**STAGE 1 STATE SIGNIFICANT
DEVELOPMENT ASSESSMENT REPORT**

**1 ALFRED STREET, 19-31 PITT STREET
AND 31A PITT STREET, SYDNEY**

D/2015/1049 (SSD 15_7101)

Figure 9: Tower B envelope lodged (left) and revised (right) (Source: Applicant's design study)

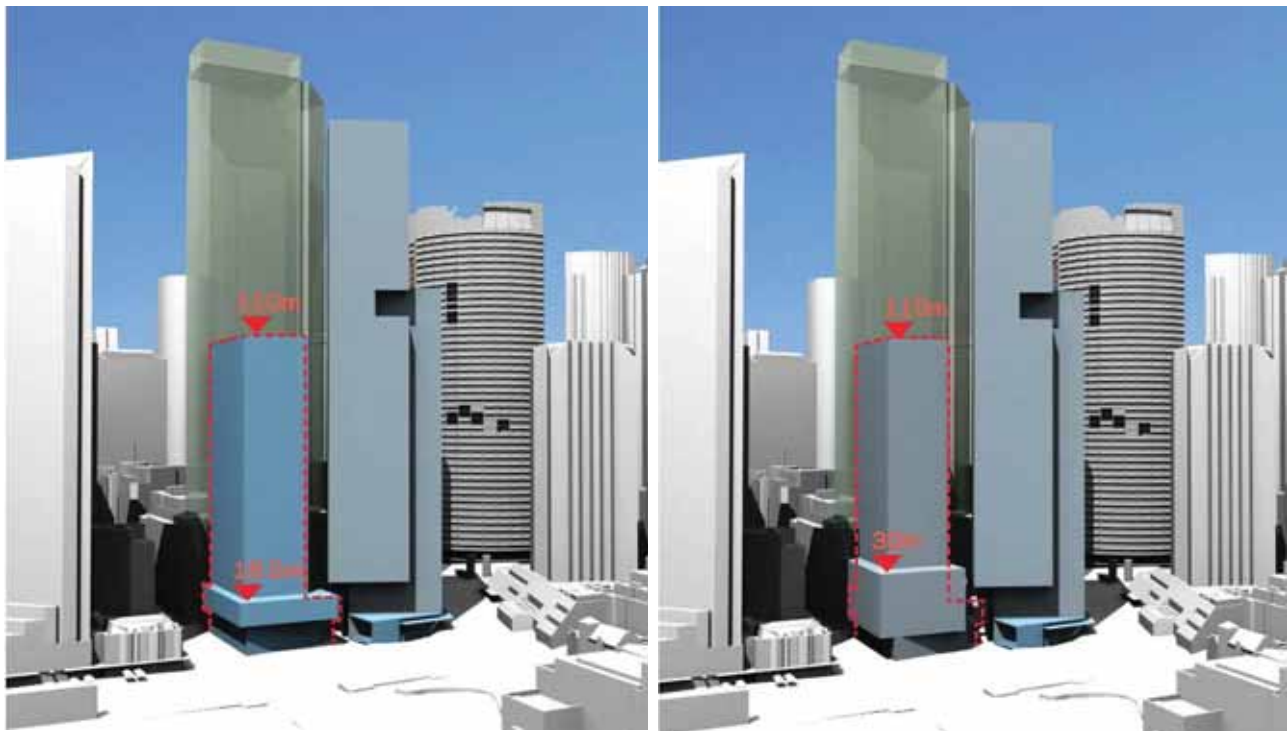
The proposal has been modified to address concerns raised by Council relating to the design of Tower B. The originally submitted envelope for Tower B proposed a floor plate of approximately 943sqm and a maximum podium height of 18m (**Figure 9**).

The originally proposed Tower B built form was not considered to be appropriate. The 18m podium height created an inconsistent street wall height along Pitt Street. The indicative floor plate was considered to be inefficient and opportunities were identified to relocate GFA from the tower portion of the building to the podium in order to create a more consistent street wall height along Pitt Street and reduce the visual impact of the tower element. The originally proposed podium also resulted in a narrowing of the 'open to sky' element of the through-site link between Tower A and Tower B (**Figure 10**).

The revised proposal contained within the RtS addresses the above concerns. The floor plate of Tower B has been rationalised by reducing the size of the core and room sizes, resulting in a reduction in building depth by 2m and a reduced building envelope area of 855sqm. By increasing the podium street wall height to 30m from 18m, this has allowed more of the GFA to be relocated to lower levels, improving view and solar access to surrounding properties and public spaces.

Figure 10: Lodged (left) and revised (right) north/south through site link (Source: Applicant's RtS)

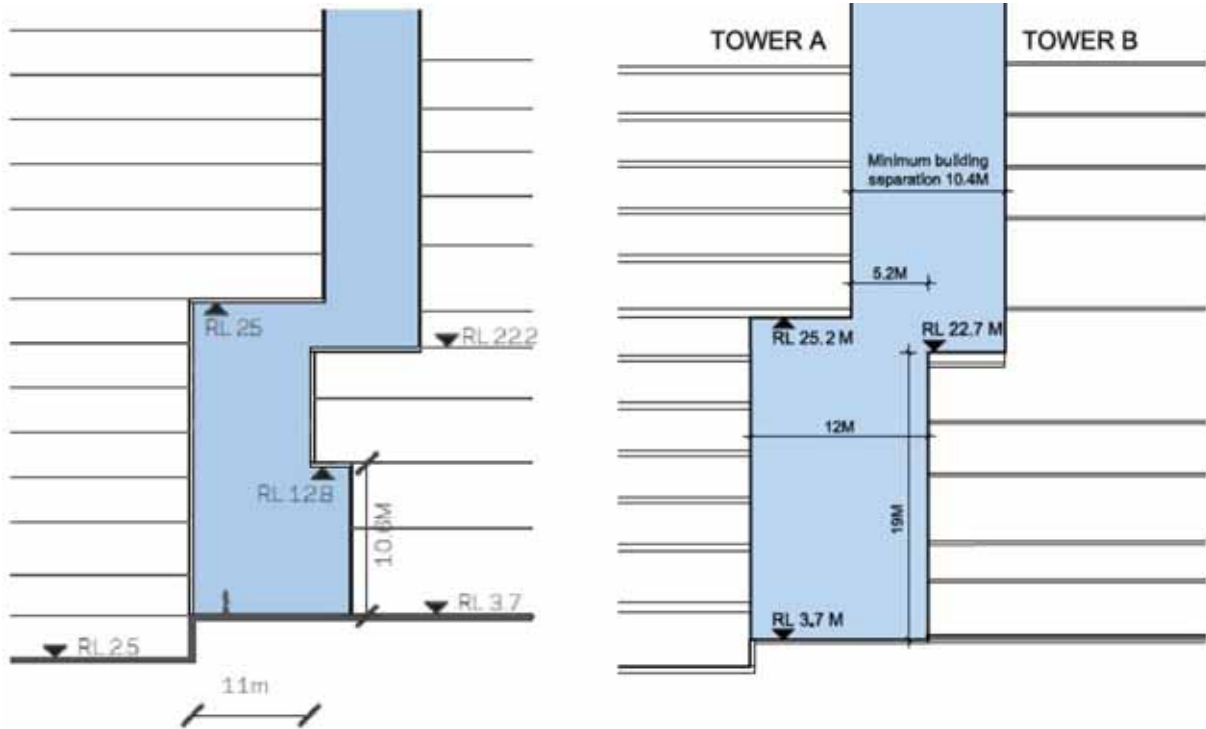
Modifications to the podium also assisted in providing a more 'open to the sky' through-site link) between the towers, as well as increasing the ground floor separation between buildings from 11m to 12m (**Figure 10**).

Figure 23: Currently existing and currently approved buildings (above) vs proposal (below), as viewed from 200 George Street at RL 140m (Source: Applicant's EIS)

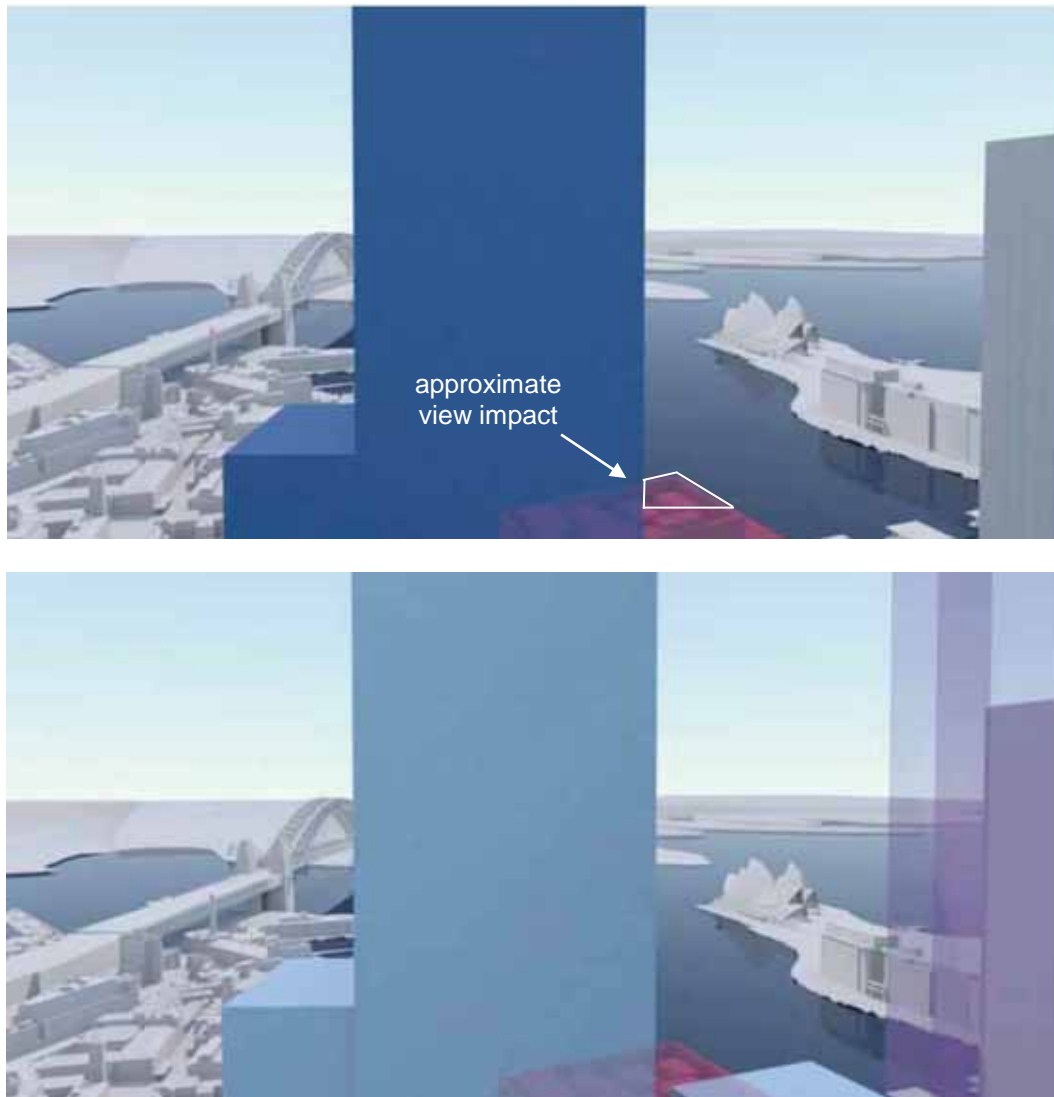
200 George Street is a 37 storey commercial tower currently under construction. As demonstrated in **Figure 23** below, the proposal will have negligible impact on the previously approved outlook from 200 George Street to significant landmarks from RL 140m, including the Opera House and Harbour Bridge. A small portion of water view is lost, however this is offset by the water view gain as a result of the demolition of Goldfields House. The loss of views to the Harbour Bridge as a result of the minor expansion of the Tower A envelope cannot be discerned.

- As demonstrated in **Figure 23** above, iconic Opera House views are still maintained to other levels within the building, above a height of 110m.
- The amount of view lost is a small portion in comparison to the overall floor plate, building height and opportunities for views from the north western corner of the site to the Harbour Bridge.

Figure 24: Currently existing and currently approved buildings (above) vs proposal (below), as viewed from 200 George Street at RL 90m (Source: Applicant's EIS)

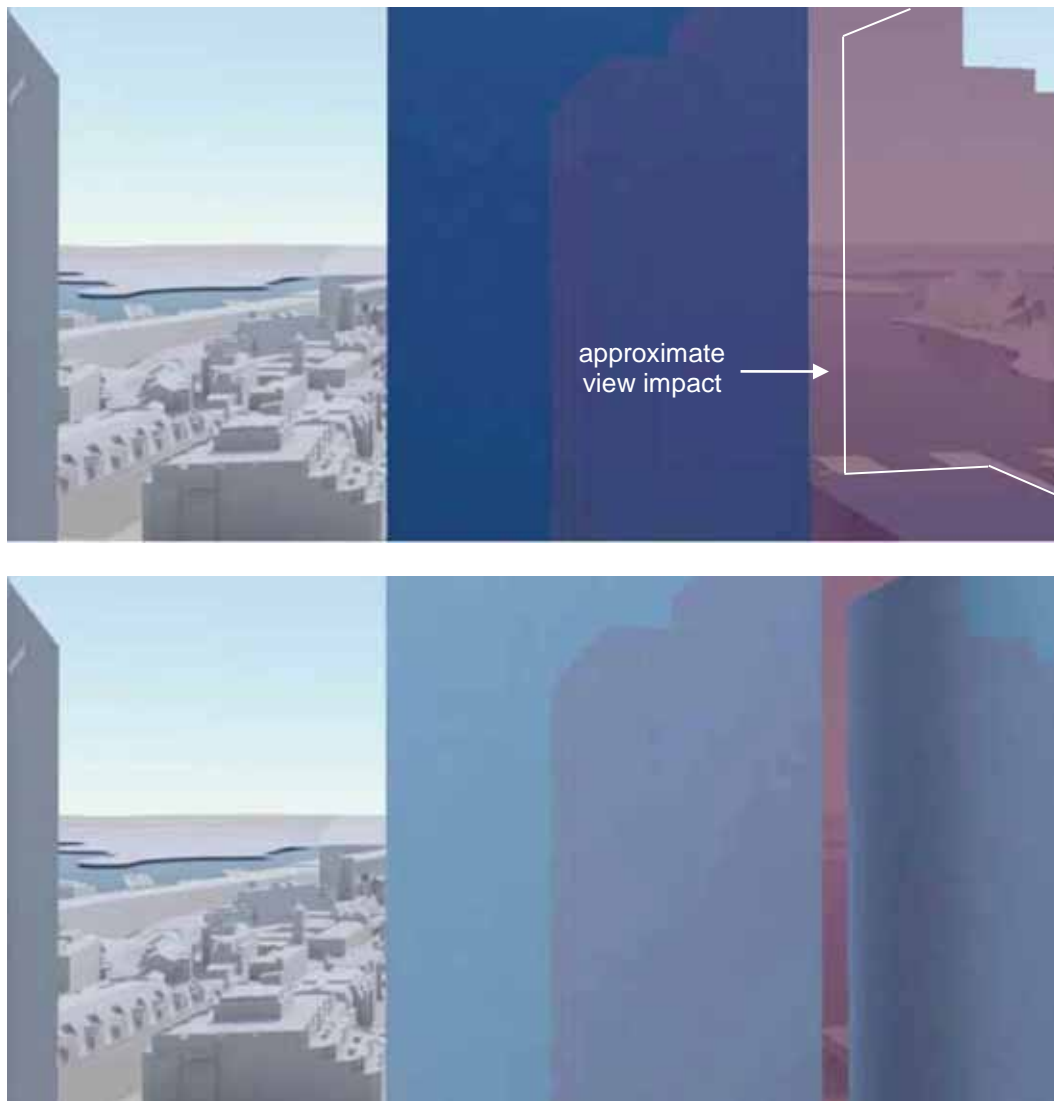
Figure 24 below shows that at lower levels (RL 90m) 200 George Street would be afforded a full view to the Opera House as a result of the demolition of Goldfields House, if the proposal approved under D/2010/2029 was constructed. This view gain was offset by a loss of Harbour Bridge views as a result of Tower A approved under D/2010/2029. Under the current proposal, the view gain to the Opera House is also removed due to the increase in height of Tower B to 110m from the 55m approved under D/2010/2029.

Figure 25: Extent of views still received from 200 George Street despite the lodged proposal (left) and revised proposal (right) (Source: Applicant's RtS)

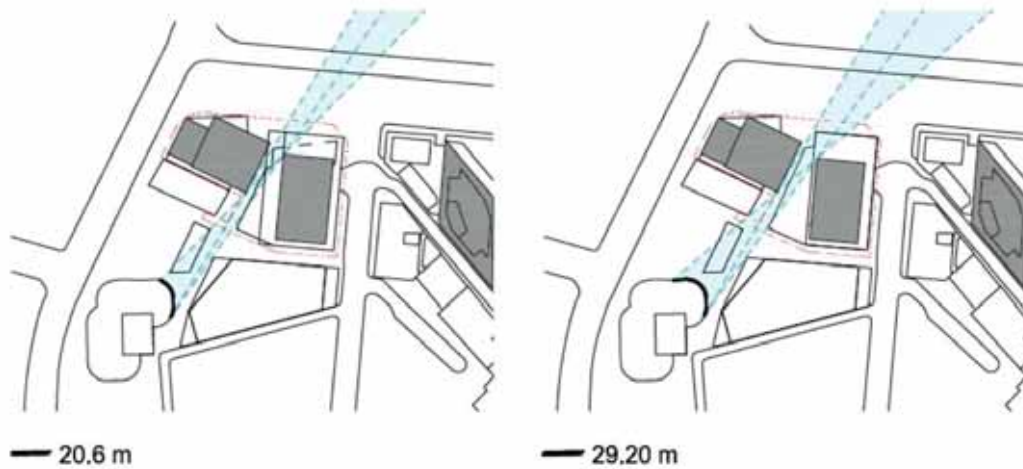
- As shown in **Figure 25** below, the view corridors proposed through the site will still allow for an appropriate level of view sharing from the north eastern corner of the building.

Figure 26: Currently existing and currently approved buildings (above) vs proposal (below), as viewed from the future Lend Lease site at RL 140m (Source: Applicant's EIS)

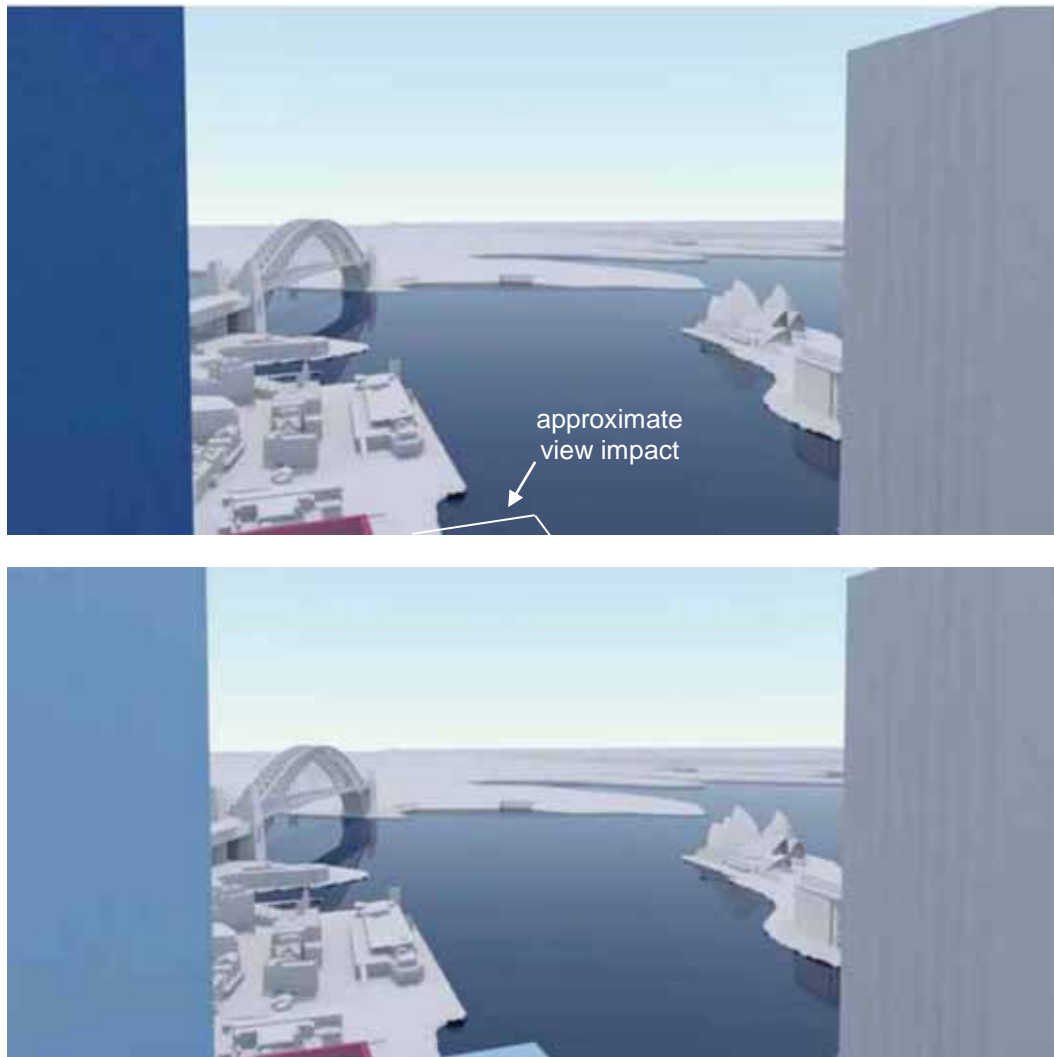
As demonstrated in **Figure 26** below, the proposal will have negligible impact on the previously approved outlook from future views from the proposed Lend Lease building to significant landmarks from RL 140m, including the Opera House and Harbour Bridge. A small portion of water and the Harbour Bridge southern pylon is lost, however this is considered acceptable in the context of views to the Harbour Bridge that are maintained.

- As demonstrated in **Figure 26** above, iconic Harbour Bridge and Opera House views are still maintained to other levels within the building, above a height of 110m.

Figure 27: Currently existing and currently approved buildings (above) vs proposal (below), as viewed from the future Lend Lease site at RL 70m (Source: Applicant's EIS)

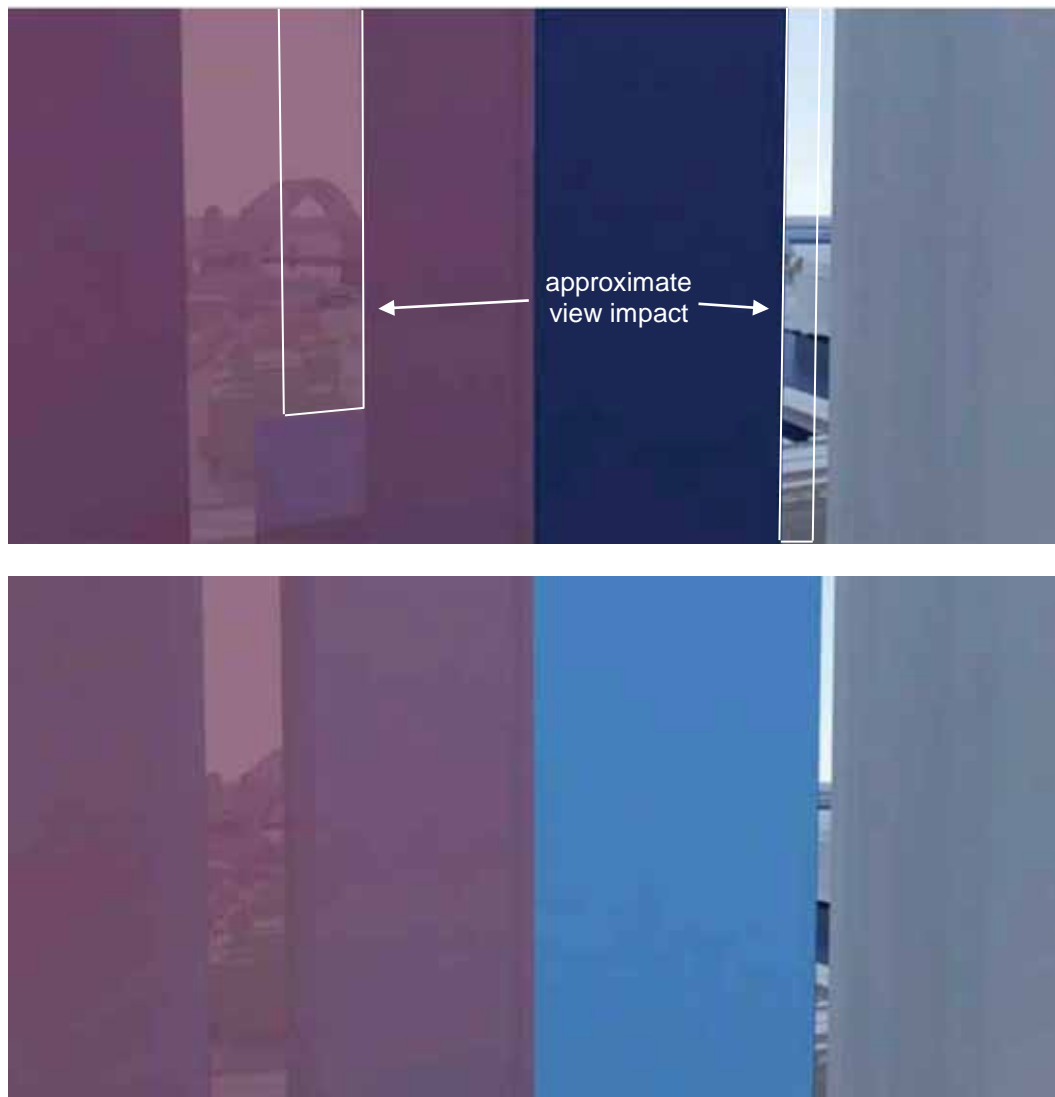
Figure 27 below shows that at lower levels (RL 70m) the future Lend Lease building would be afforded a considerable view gain to the Harbour Bridge as a result of the demolition of Goldfields House, if the proposal approved under D/2010/2029 was constructed. Under the current proposal, the view gain to the Harbour Bridge is reduced. The proposal reduced a minor view gain to the south eastern corner of the Opera House.

Figure 28: Extent of views still received from the Lend Lease site despite the lodged proposal (left) and revised proposal (right) (Source: Applicant's RtS)

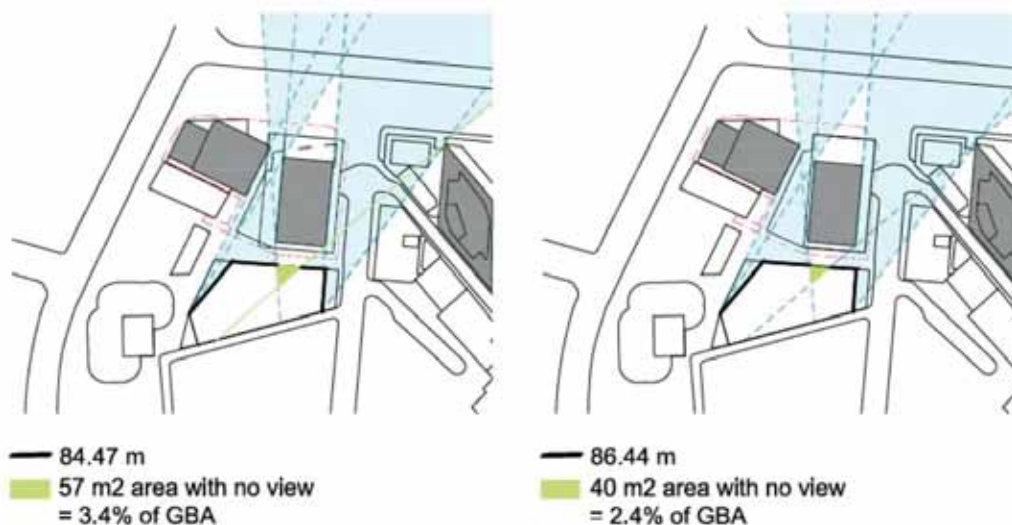
- As shown in **Figure 28** below, the view corridors proposed through the site will still allow for an appropriate level of view sharing from the northern elevation.

Figure 29: Indicative site access and set-down/pick-up (Source: Applicant's RtS)

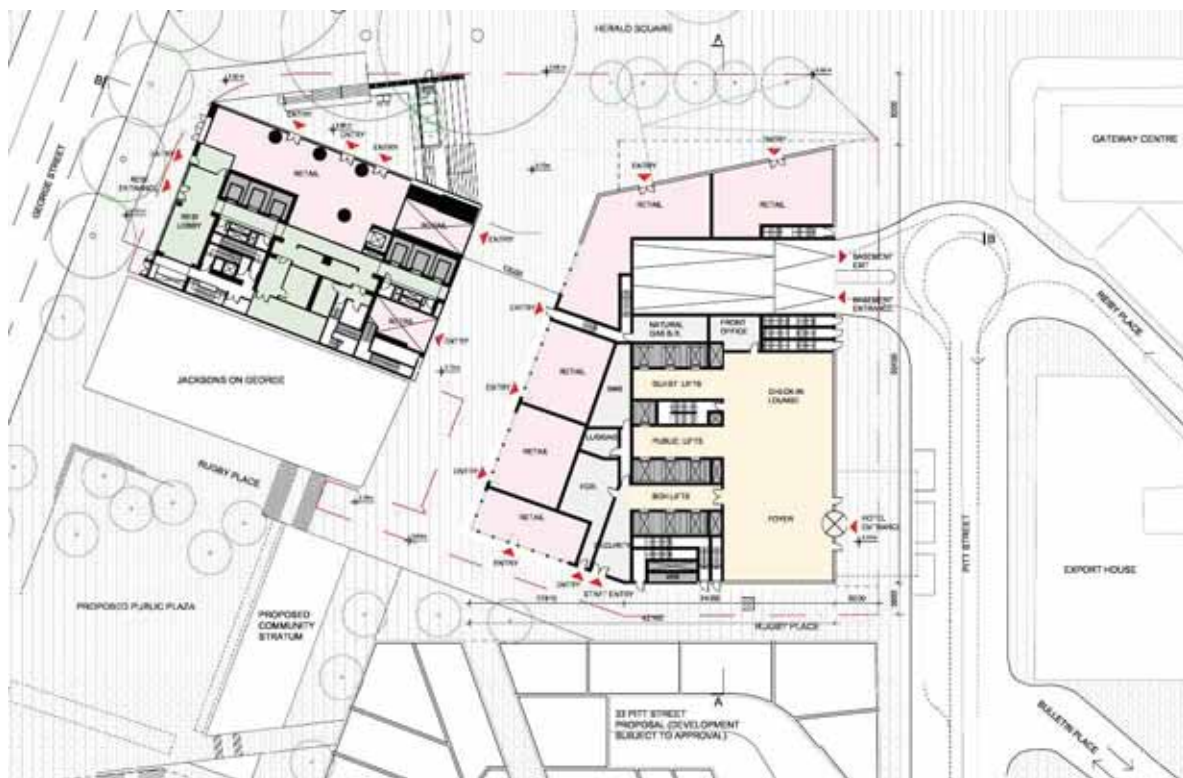
Access to the basement levels is currently proposed via an ingress and egress driveway approximately 10m wide, located at the northern end of the Pitt Street site frontage (**Figure 29**). The proposed driveway would result in the consolidation of existing vehicle access points across the site into one single entry at Pitt Street.

Due to the uncertainty of the final design of Pitt Street including the exact location and turnaround design options for the closure of Pitt Street south of Alfred Street, the location of the driveway cannot not be approved at this time. Conditions have been recommended requiring ongoing consultation with the with CBD Coordination Office, CBD and South East Light Rail Project Team and Council during the design competition and Stage 2 details design to ensure all traffic / transport interface issues along Pitt Street are addressed. Relevant future applications will also be referred to the Central Sydney Traffic and Transport Committee (CSTTC).
